Office Action Summary

10/750,433

CLARK ET AL.

ATTACHMENT 1

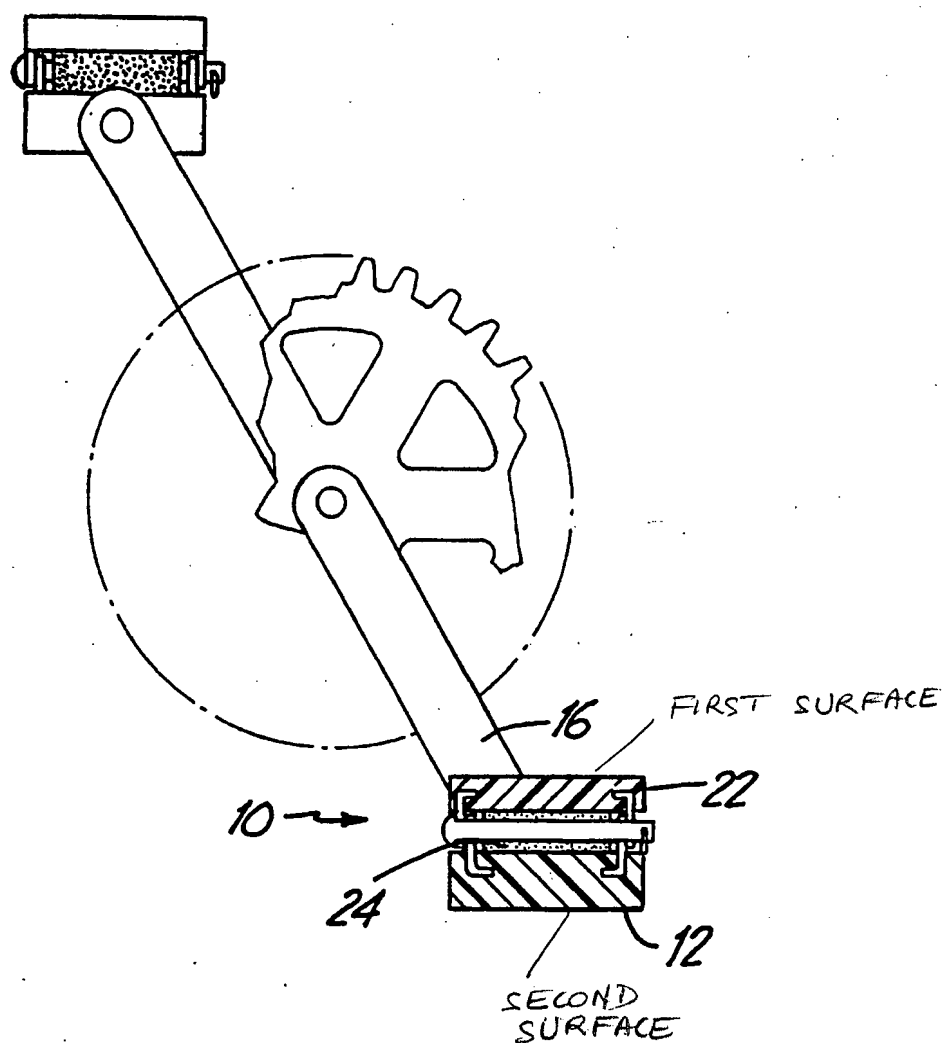
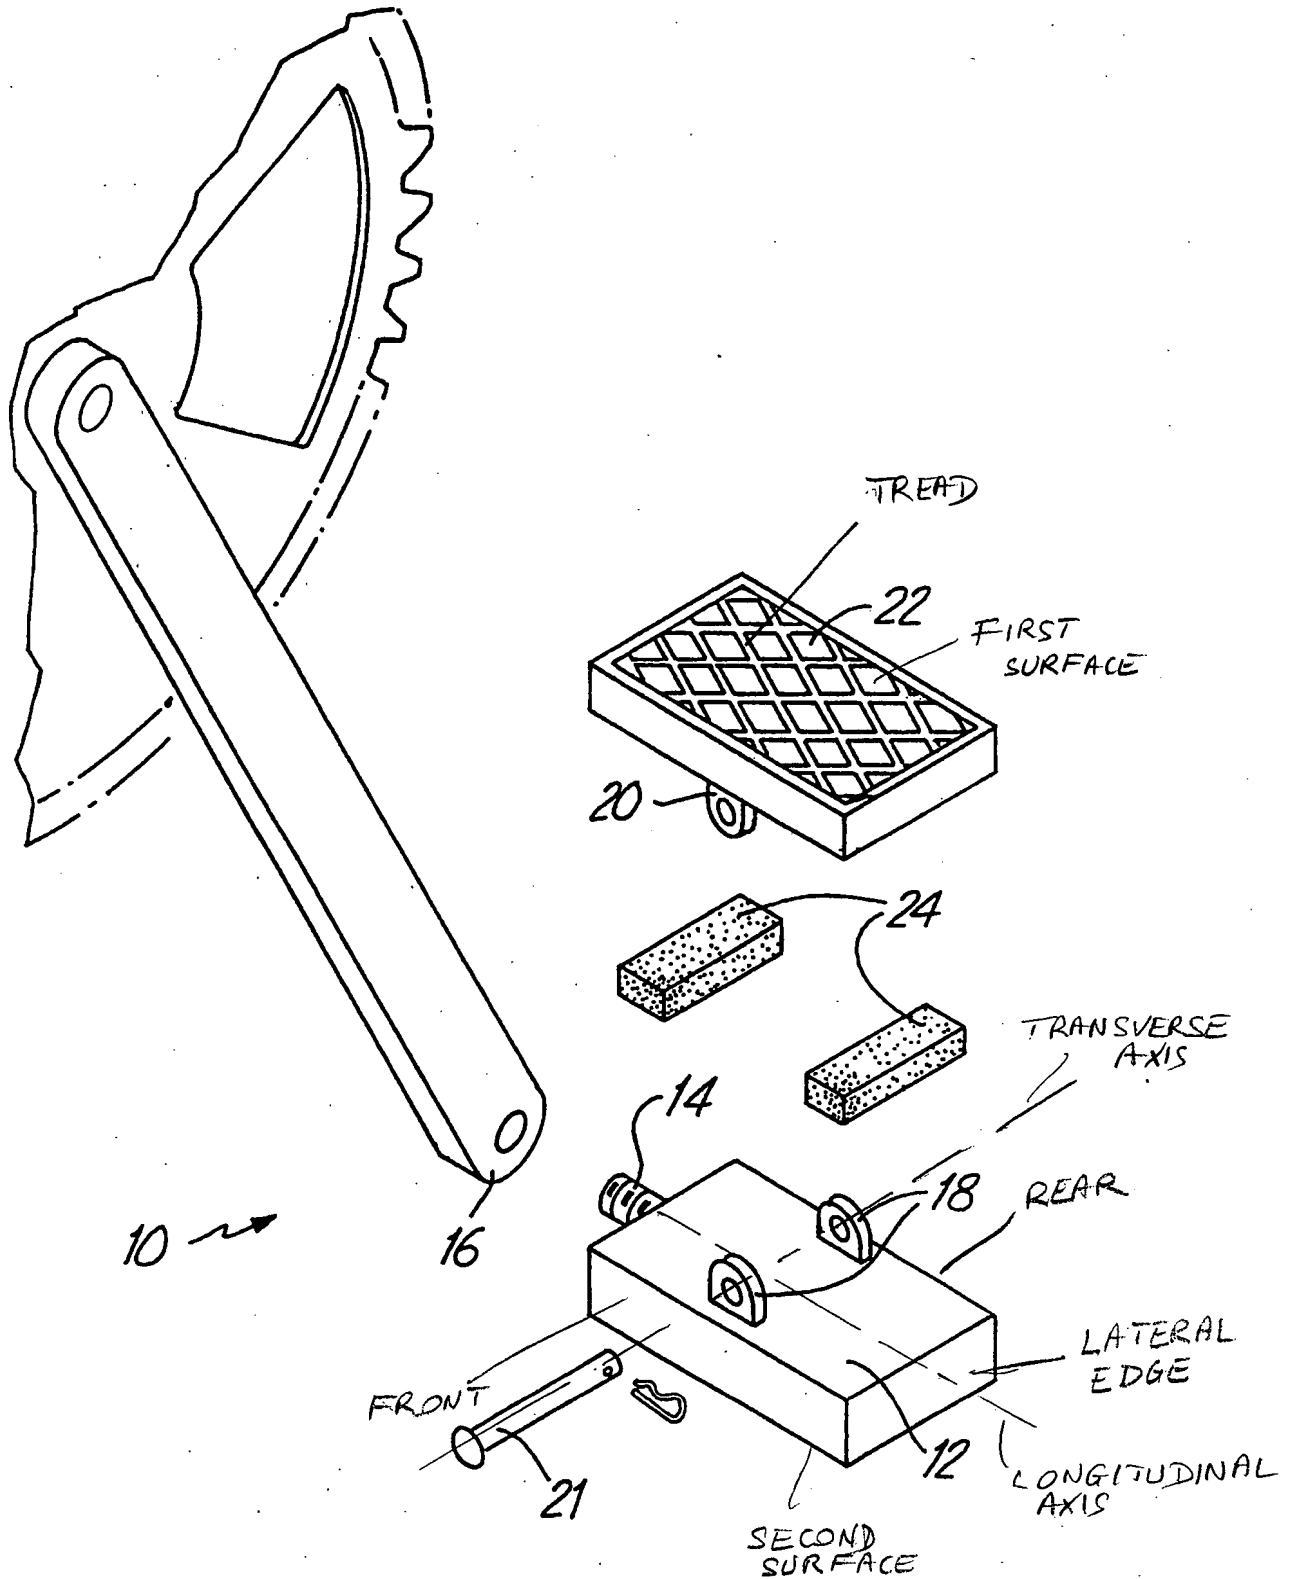
Hervig'332 teaches an apparatus 10 comprising a reversible pedal body 22, 12 having first and second surfaces 22 and 12 (see Attachment 1 hereinafter "Att. 1"), wherein said first surface 22 is adapted to contact an associated foot, said second surface 12 is adapted to contact an associated shoe, said pedal body 22, 12 having a front (Att. 1) oppositely disposed from a rear (Att. 1), said pedal body 22, 12 having first and second lateral edges (Att. 1) extending between said front and said rear, said pedal body 22, 12 having a longitudinal axis (Att. 1) and a transverse axis 21 (Att. 1), said pedal body 22, 12 being operatively connected to an associated exercise device (weight lifting equipment and bicycle), said pedal body 22, 12 further comprising a first weight 24 and a second weight 24 operatively connected to said pedal body 22, 12, such that one of said surfaces 22, 12 faces substantially upwards as said pedal body 22, 12 approaches an equilibrium position, said first and second weights 24 being oppositely disposed and substantially equidistant from said transverse axis 21 (FIG. 3).

Claim 1 is anticipated by Hervig'332 because Hervig'332 teaches each positively claimed element and its functional statement. On the one hand, Hervig'332's elements 24 inherently are subjected to the gravitational force of the earth. Therefore, they must have an amount or quantity of heaviness, i.e., mass or weight. Therefore, the elements 24 "read on" the claimed weights. On the other hand, it has long been held that the recitation that an element is "adapted to" perform a function is not a positive limitation but only requires the ability to so perform. It does not constitute a limitation in any patentable sense. *In re Hutchison*, 69 USPQ 138 (CCPA 1946).

Regarding claims 8 and 17, Hervig'332 teaches the tread on the first surface (Att. 1) in order to provide friction engagement. It would have been obvious to one having ordinary skill in the art at the time the invention was made to form the tread on Hervig'332's second surface in order to provide friction engagement as taught or suggested by Hervig'332. The use of tread to provide friction is notoriously well known in the art of bicycle pedal.

ATTACHMENT 2

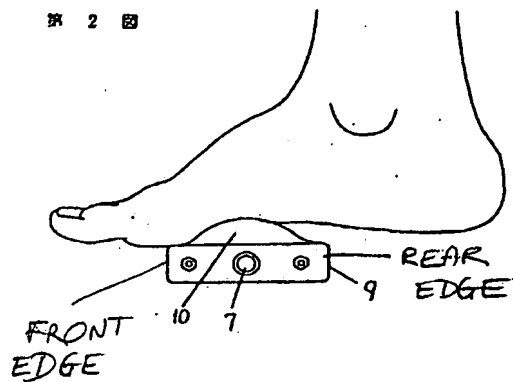
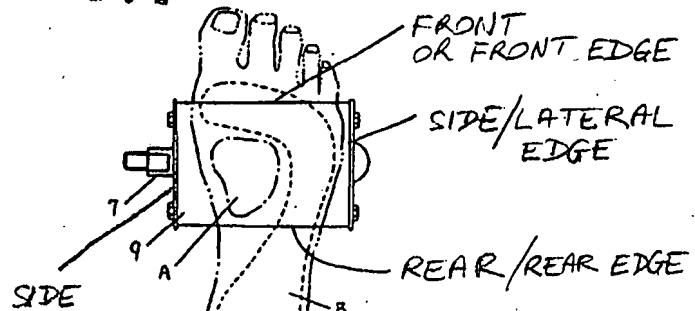
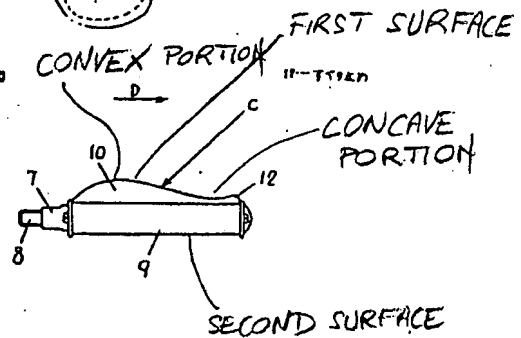
Regarding claim 3, Mitsuo's first surface comprises a concave portion (Att. 2) and a convex portion (Att. 2) so as to *substantially* conform to an arch A of a foot B. Mitsuo, abstract.

Regarding claim 4, Mitsuo's first surface (Att. 2) comprises a front edge *substantially* flush with said rear of said pedal body; and a rear edge *substantially* flush with said front of said pedal body 9, 10 as seen in Fig 2.

Regarding claim 5, Mitsuo's front edge (Att. 2) is left or right directional.

Regarding claim 13, Mitsuo's first surface further comprises a rear edge (Att. 2), said first surface (Att. 2) has a concave portion (Att. 2) transitioning into a convex portion (Att. 2).
